KARACHI MUNICIPALITY.

ORDER UNDER SECTION 96 (2) OF ACT. III OF 1901.

I have to inform you that the plan submitted by you for building making houses on plot No. 50 sheet No. N.P-5, Majra Quarter, is approved and permission to build in accordance therewith is granted. The building must be erected in accordance with the approved plans and deviations should not be made without previous sanction of the Municipality.

PLAN OF PROPOSED BUILDING
SHEET N. 50 SHEET N. P. 5.
PIPER QUARTER
SCALE 8:1 INCH

PLAN OF PROPOSED BUILDING
ON N. 50 SHEET N. 50
PIER QUARTER
SCALE 8:1" INCH

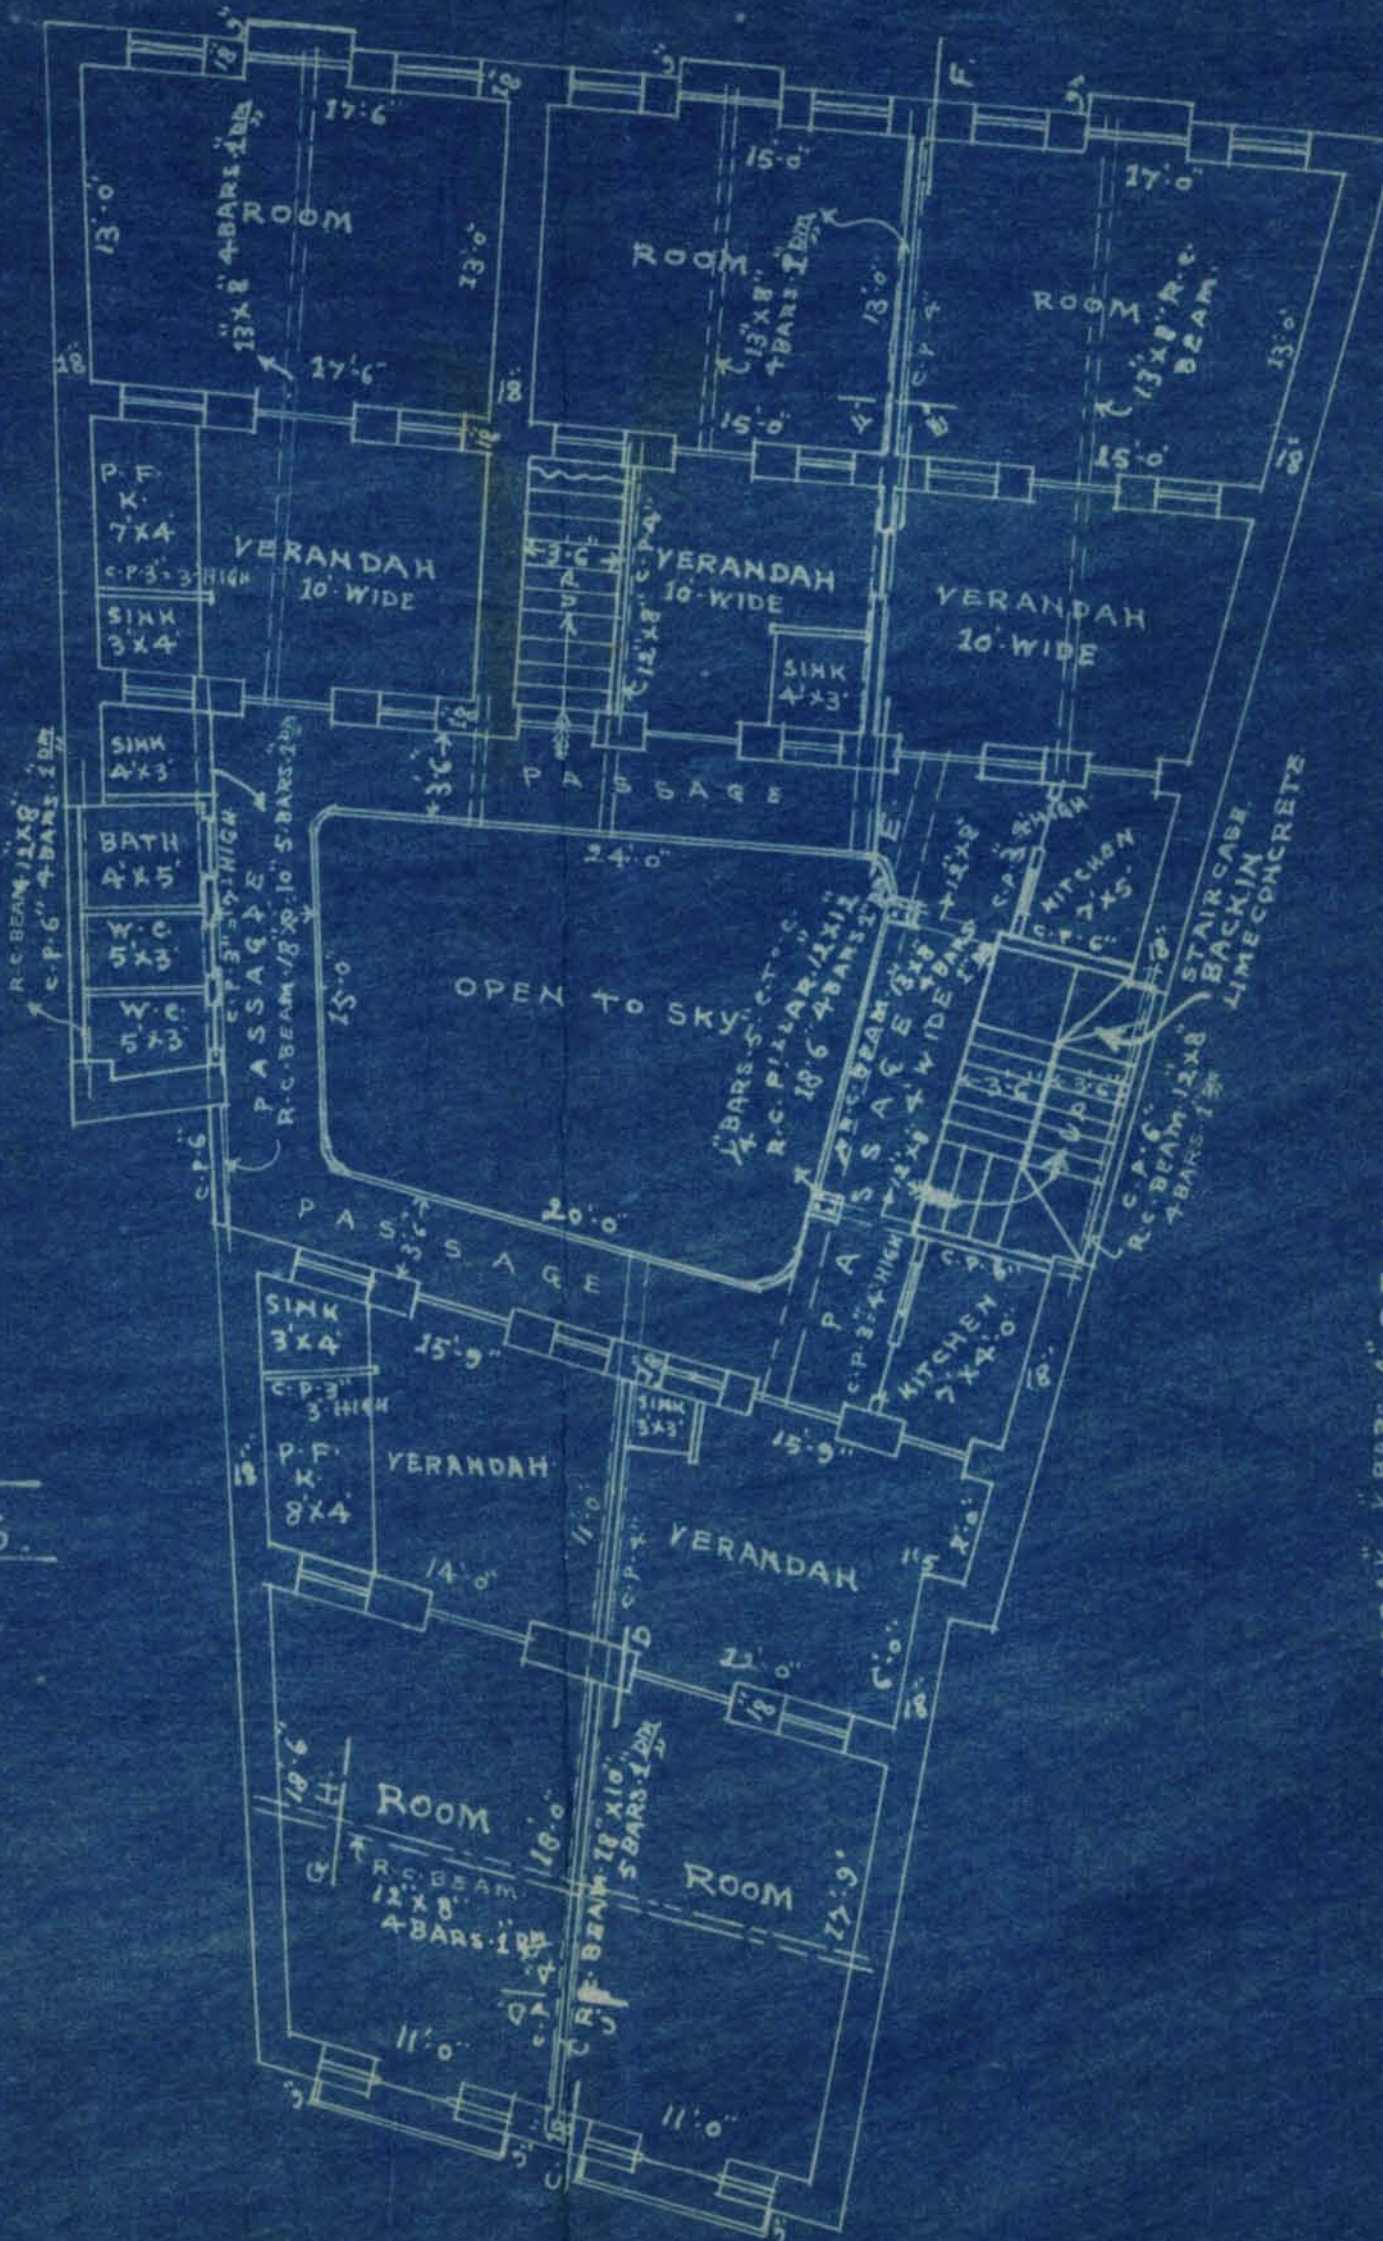
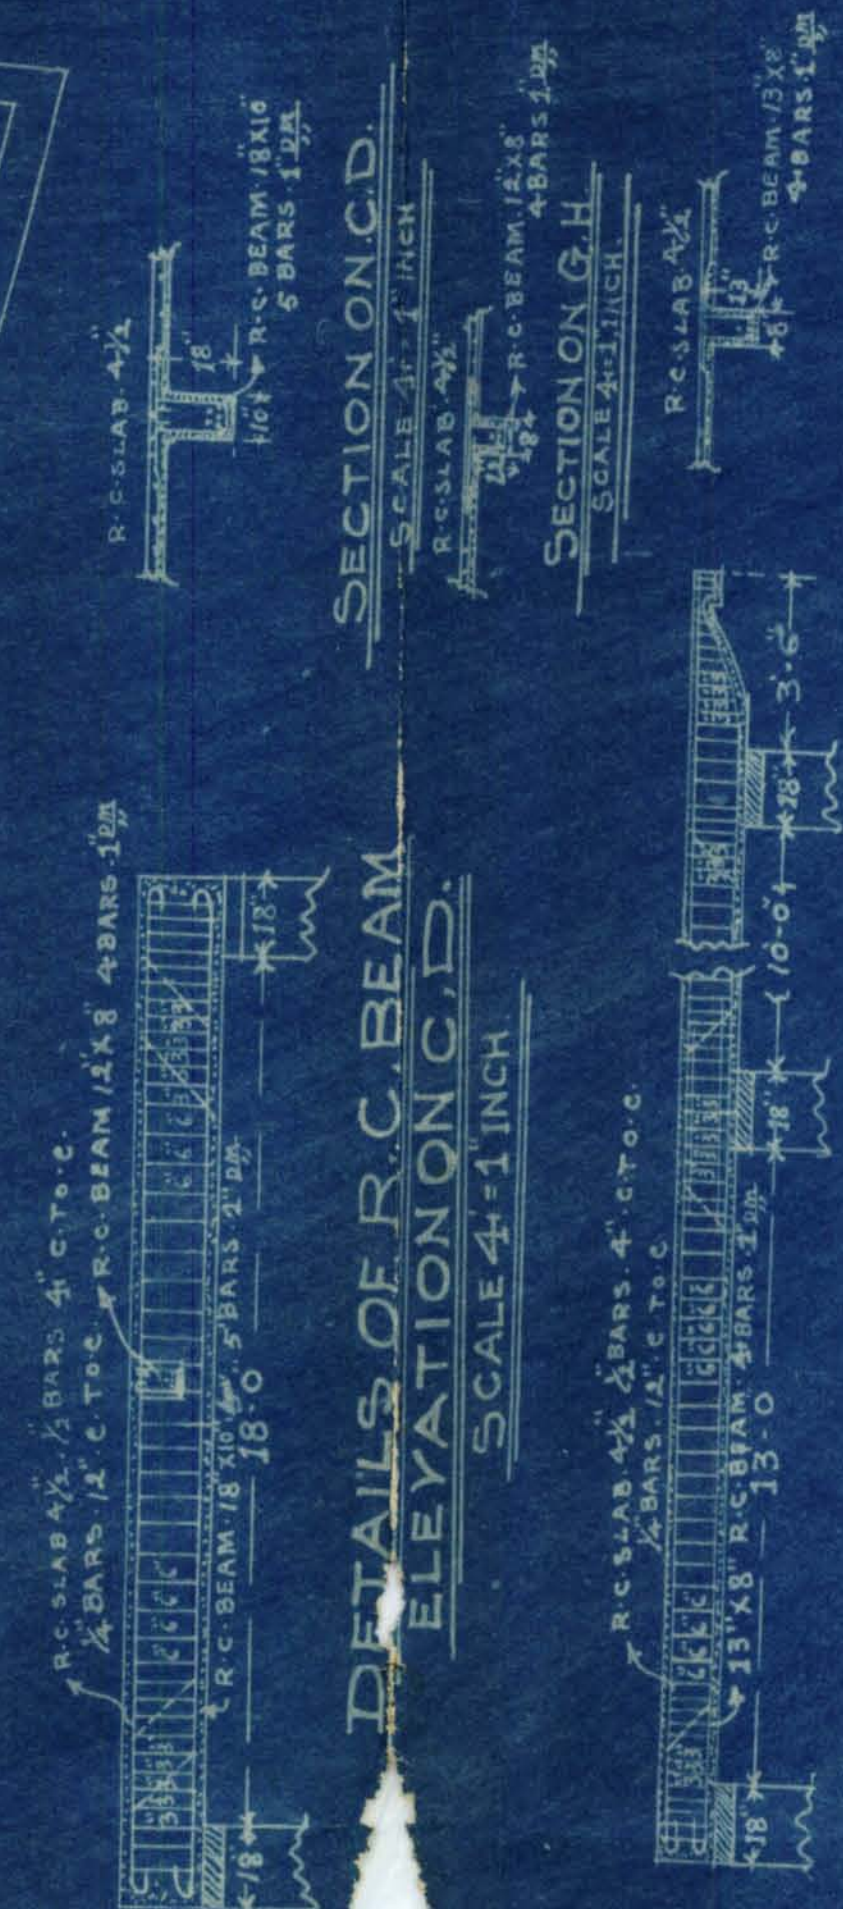
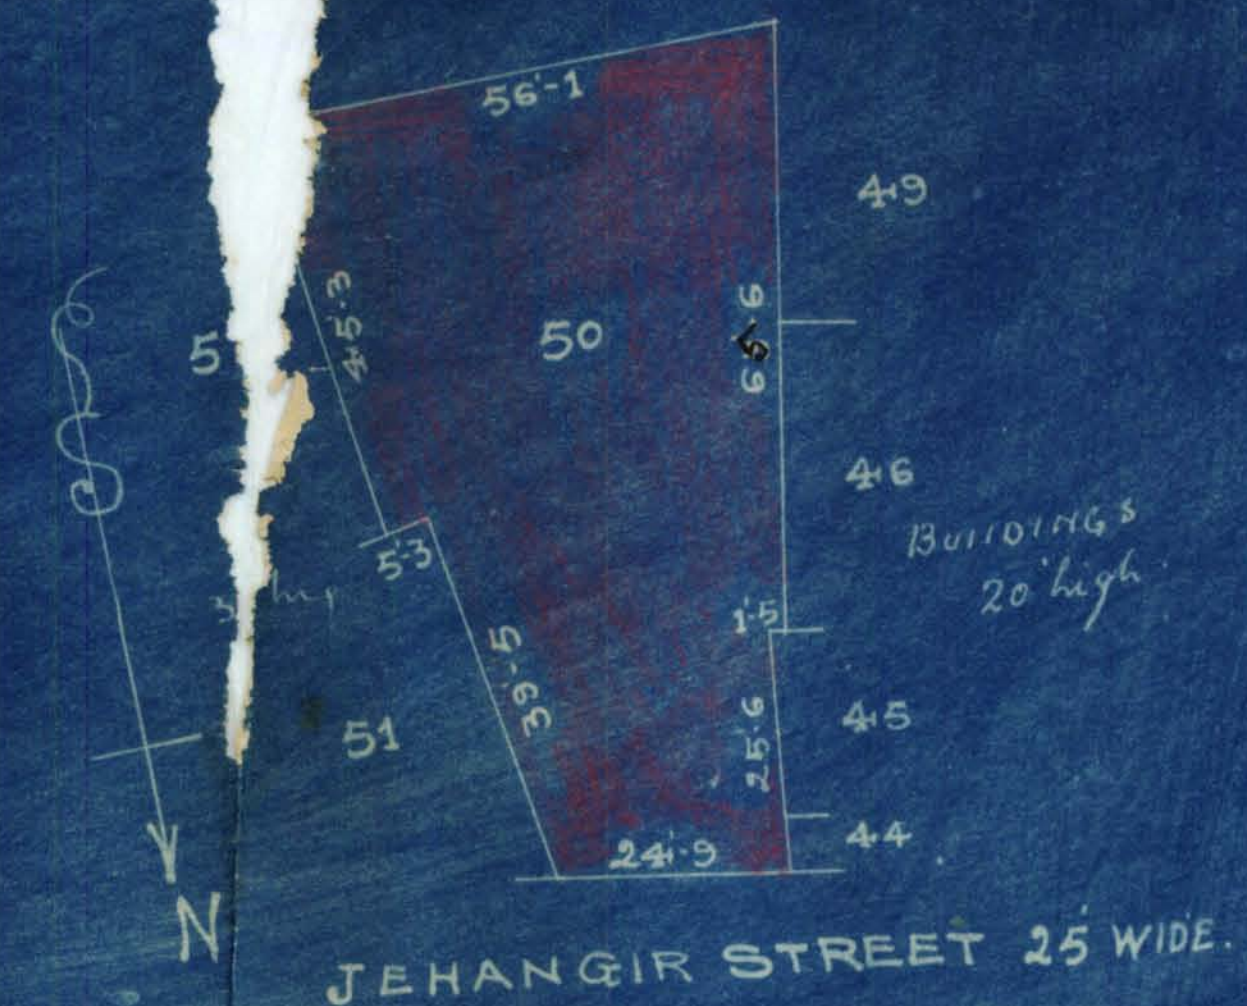
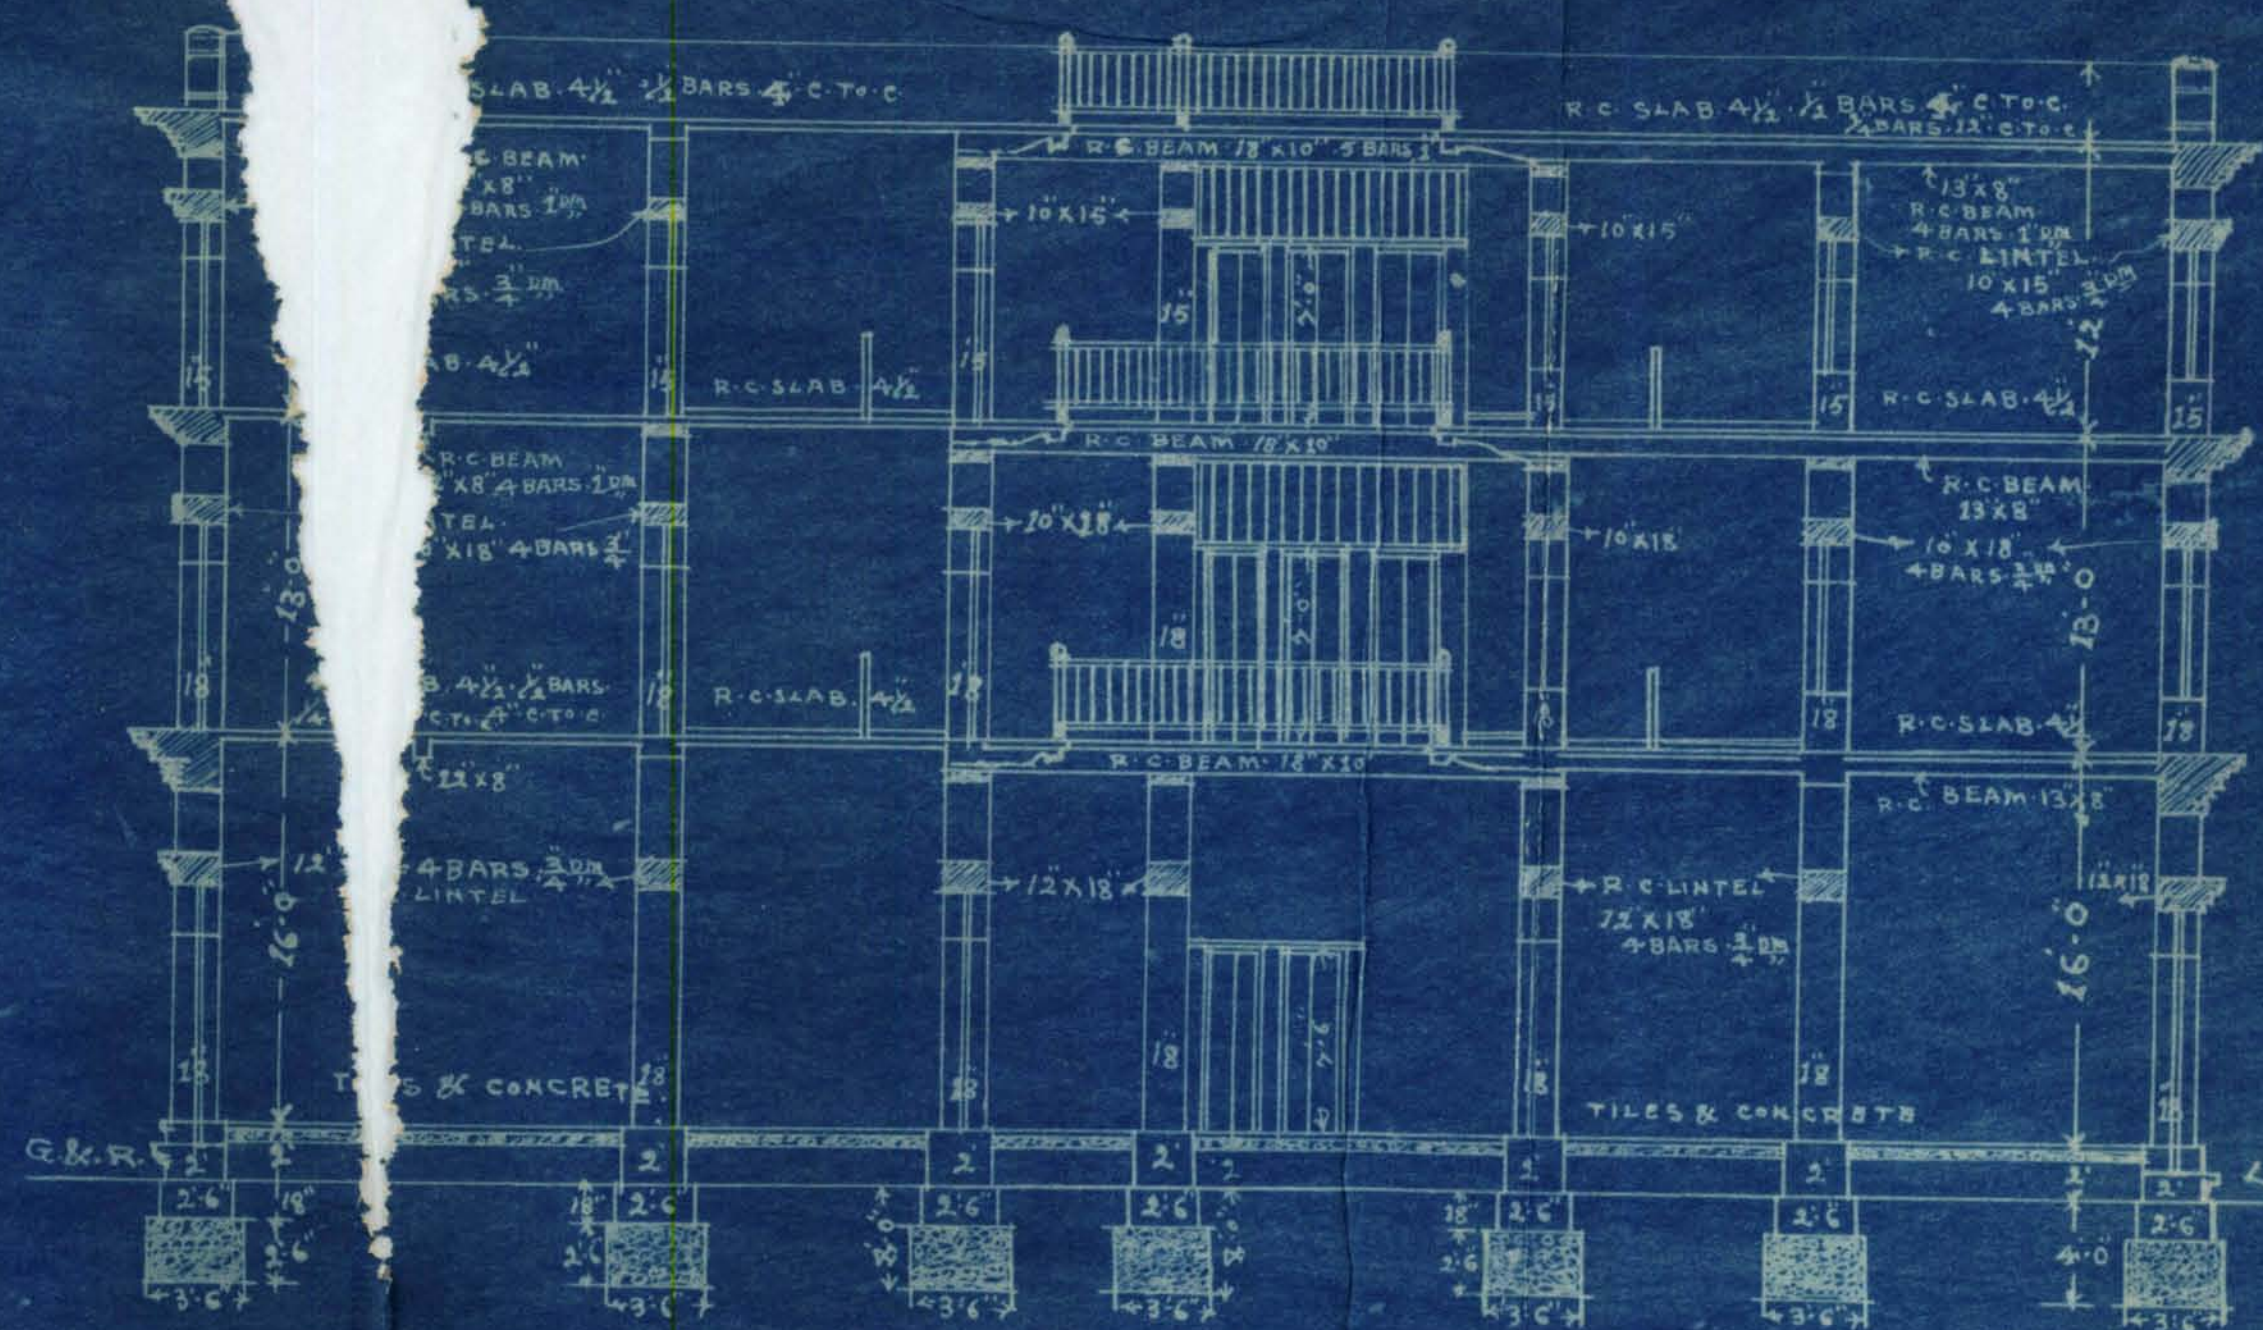
- (1) Central pillar should be of Amman wall by the side of staircase to be of non-inflammable
- (2) material.
- (3) kitchen k. cannot be allowed.
- (4) Re column c must be 15" x 15"
- (5)
- (6)
- (7)
- (8)
- (9)

- (1) Central Pillar will be of similar
masonry as shown
 - (2) There will be no wall by the
side of staircase only there will be
railing with balustrade of non inflammable.
 - (3) Kitchen K has been deleted.
 - (4) R.C column C has been shown 15" x 15"
- The Plans to be approved.
